**Hurstville City Council**  
*Office of the General Manager*

Director, Infrastructure Projects Planning Services  
NSW Department of Planning and Environment  
Application number SSI 6788  
G P O Box 39  
SYDNEY NSW 2001

# Hurstville City Council Submission to the Environmental Impact Statement for the Westconnex New M5 Project

Figure 2 Indicative Longitudinal Road Tunnel Ventilation System

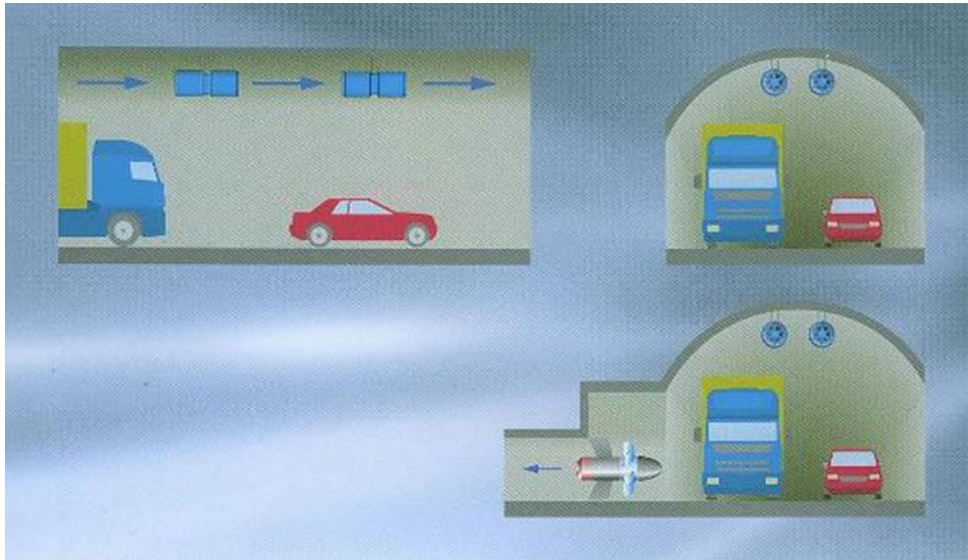
Given that a longitudinal ventilation system is proposed, any required upgrade of the overall system will in all likelihood involve an upgrade to that longitudinal system, as reflected in the above comment.

If the initial longitudinal ventilation does require modification and upgrade, which is considered likely, that will in all probability involve additional fresh air inlet points, and two or possibly more additional exhaust air discharge points.

***An alternative tunnel ventilation approach (or approaches) is (are) included in the project proposal, and modelled in the working paper and EIS, to provide any necessary improvement in operational in-tunnel air quality, should that be required;***

*Figure 3 Indicative Transverse Road Tunnel Ventilation System*

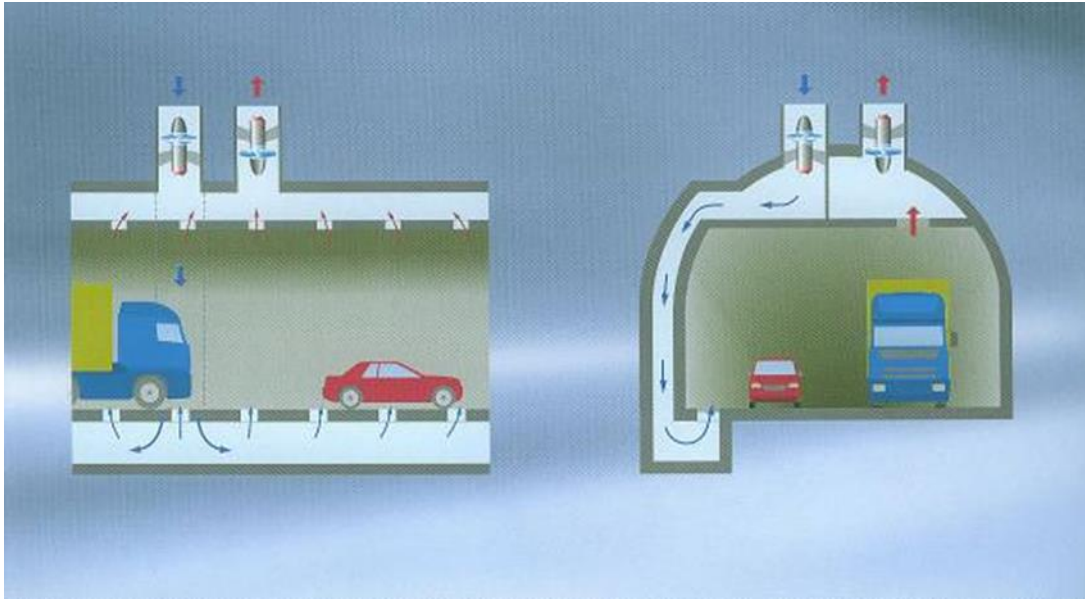
**Recommendation 1.2:** That a contingency strategy based on alternative tunnel ventilation approaches and the management of in-tunnel air, such as Transverse Ventilation be fully incorporated into the project proposal and modelled in the working paper and EIS.

Figure 4 Groundwater drawdowns predicted

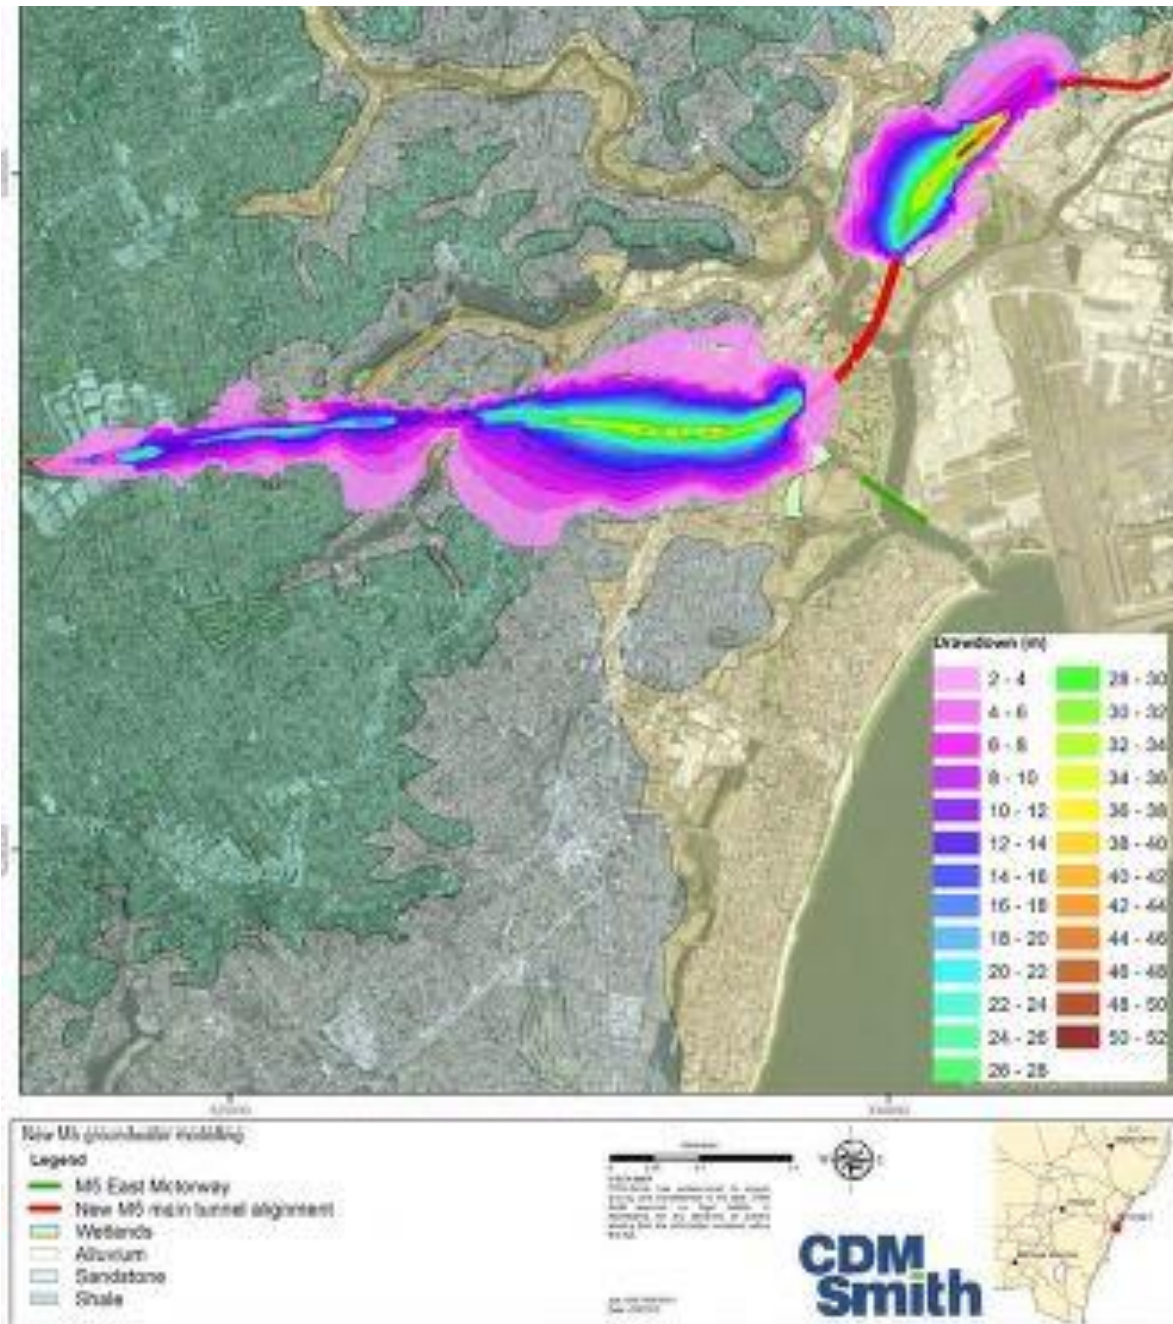
The groundwater modelling report quite clearly states that saltwater intrusion will take place, and the groundwater would ultimately be saline, at a salinity approaching that of seawater (CDM Smith, 2015). Looking at the impacts predicted in Figure 4, this could be expected to occur across all areas between the pink shading and the surface water bodies within this section would be expected to become more saline, then extending potentially to the centre of the tunnel alignment.

The impact on water quality has not been considered. It should be as it is directly as a

result of groundwater drawdown arising from the project.

Figure 5 Induced Recharge

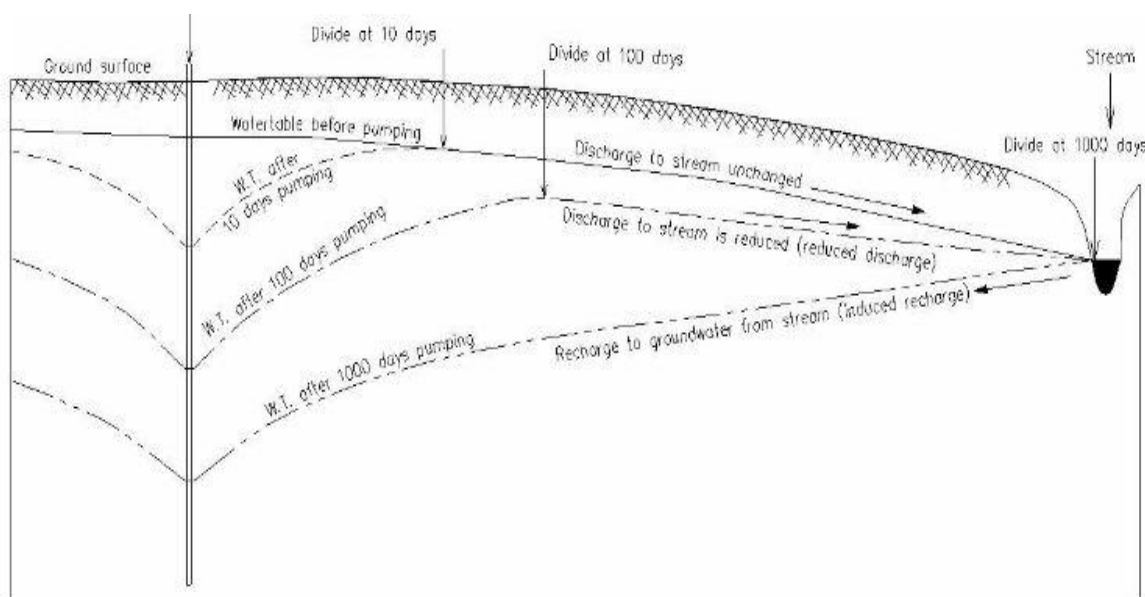
Further, the technical working paper does not discuss that induced recharge, or induced leakage, is likely to also occur. This describes the transition from a gaining stream to a losing stream that may occur as a water table falls. This is illustrated in Figure 5 (Land & Water, 2007). This will impact those tributaries to the Cooks River that are above the tidal range that are in a natural state. However, as there's been no consideration of this in the groundwater modelling exercise, the extent of this impact is not predicted and has not been considered in the assessment.
